# PLANNING DIVISION STAFF REPORT

**Project Address:** 3901 Packers Avenue (District 18, Alder Myadze)  
**Application Type:** Planned Development District Alteration  
**Legistar File ID #:** [83737](#)  
**Prepared By:** Lisa McNabola, AICP, Planning Division  
Report Includes Comments from other City Agencies, as noted  
**Reviewed By:** Kevin Firchow, AICP, Principal Planner

**Requested Action:** Consideration of an alteration to an approved Planned Mobile Home Park (PMHP) District for 3901 Packers Avenue to amend the approved site plan.

Proposed Site Plan

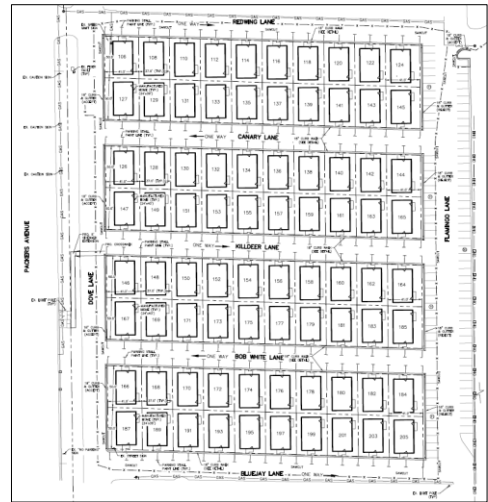
Staff note the site plan shows a stormwater management facility located partially outside of the property. The applicant will need to revise the site plan to locate the facility on their property, as noted in the recommended conditions of approval. The site plan may need to be further revised to address the recommended conditions of approval from the Fire Department. Some of the manufactured homes would be located more than 500 feet from the nearest hydrant, and the site does not provide adequate access for fire vehicles and hoses. In speaking with the applicant, they expect to revise the site plan to provide an additional fire access lane. They will continue to work with the Fire Department to ensure there is adequate fire hydrant access. The Planning Division recommends the following condition of approval to account for anticipated site plan changes, "The Planning Division Director, or their designee, may administratively approve site plan changes that address the recommended conditions of approval, which may include adding fire access lanes and removing manufactured home sites. If the Planning Division Director does not approve the changes the applicant may follow the alteration procedures per MGO Section 28.09(6)."

1. This is an extremely dense housing development generating significant runoff - that must safely reach the treatment system - detail shall be provided on how the site will be drained and how runoff will be conveyed to the detention features.

7. Revise the plans to identify the location of the public storm sewer (proposed or existing) that will serve the development show the connection of the private internal drainage system to the public storm sewer. (POLICY AND MGO OVER 10,000 SF OF IMPERVIOUS AREA 10.29 and 37.05(7)(b))

8. Revise plan set to show more information on proposed drainage for the site. Use either spot elevations and drainage arrows or proposed contours to show the required drainage information. It is necessary to show the location of drainage leaving the site to the public right-of-way. It may be necessary to provide information off the site to fully meet this requirement. (POLICY)

19. All There is berming, ditching and storm water management facilities proposed encroaching into a Permanent Easement for Outdoor Warning Siren per Document No 5765490. Remove any planned improvements or grade changes within the easement area as required by the City of Madison to protect the siren, pole and equipment.

20. There is berming, ditching and storm water management facilities proposed encroaching into a 66' wide Roadway Easement over Dane County lands to the north originally to the USA per Doc No. 667719, Conveyed to the City per Doc No 761227 and the City retained rights to the easement per Quit Claim Deed per Document No 1416749. Any Dane County approved storm water drainage improvements or construction within the Roadway Easement will require approval by and the recording of a Consent to Occupy Easement agreement with the City of Madison.

21. There is berming, ditching and storm water management facilities proposed encroaching into Dane County Airport Lands owned to the north. Applicant shall provide the recorded easement agreement allowing any storm water drainage facility construction on adjacent lands or remove and revise the plan accordingly.

22. Clearly label the right of way of Packers Avenue on all site plan sheets. Also clearly label the existing bus pad along Packers Avenue.
23. Submit a site plan in PDF format to Lori Zenchenko (lzenchenko@cityofmadison.com) for the development of a mobile home addressing plan.
24. The Addressing Plan for the entire project shall be finalized and approved by Engineering (with consultation and consent from the Fire Marshal if needed) PRIOR to the verification submittal stage of this LNDUSE with Zoning. The final approved Addressing Plan shall be included in said Site Plan Verification application materials or a revised plan shall provided for additional review and approval by Engineering.

25. Revise Bob White land to Bobwhite Lane on the plans.
26. The private street name Dove Ln is approved.
27. Provide a replacement name for Flamingo Ln as Flamingo is a duplicate street name. Submit street name suggestions to the addressing coordinator (lzenchenko@cityofmadison.com).
